Title: Cavalon 915iS Oil Tank To Fuel Pump Clearance		
AG-SB-2021-02-B-EN	Effective Date: 12 May 2021	Compliance Category: A – MANDATORY B – RECOMMENDED C – OPTIONAL
Applicability		
Aircraft type & model: AutoGyro Cavalon	Affected Serial number(s): AutoGyro Cavalon fitted with a Rotax 915iS engine	
The maintenance manual to be referenced is this stated or subsequent issue.		As per AutoGyro website
This form is the response from AutoGyro GmbH either against a problem found in the product in service requiring a containment or rectification action, or as service information for aircraft modification incorporation. For help, contact AutoGyro on 49(0)5121 88056-00, or email airworthiness@auto-gyro.com.

Reason and overview of the Service Bulletin (cause of problem if known)

(Pic. 1)

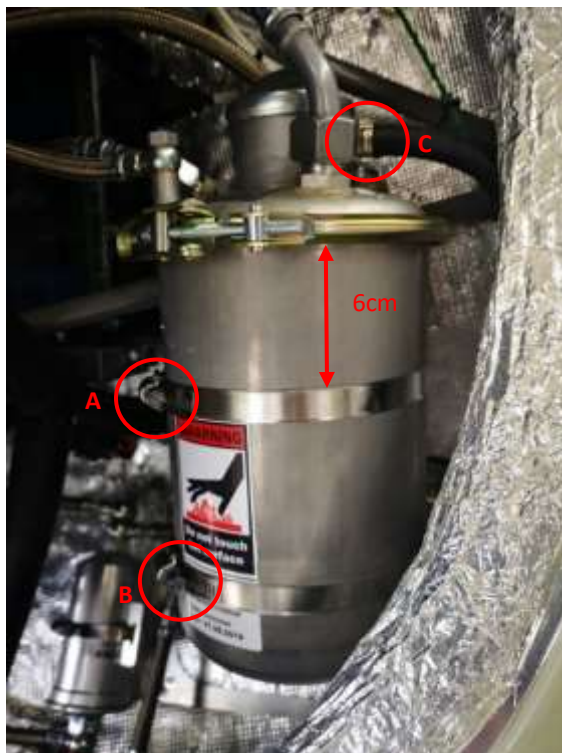
2. Determine the position of the Rotax oil tank. It should be mounted with the lip *above* the engine mounting frame horizontal strut, with a minimum of 3mm clearance between clamp and strut (Pic. 1).
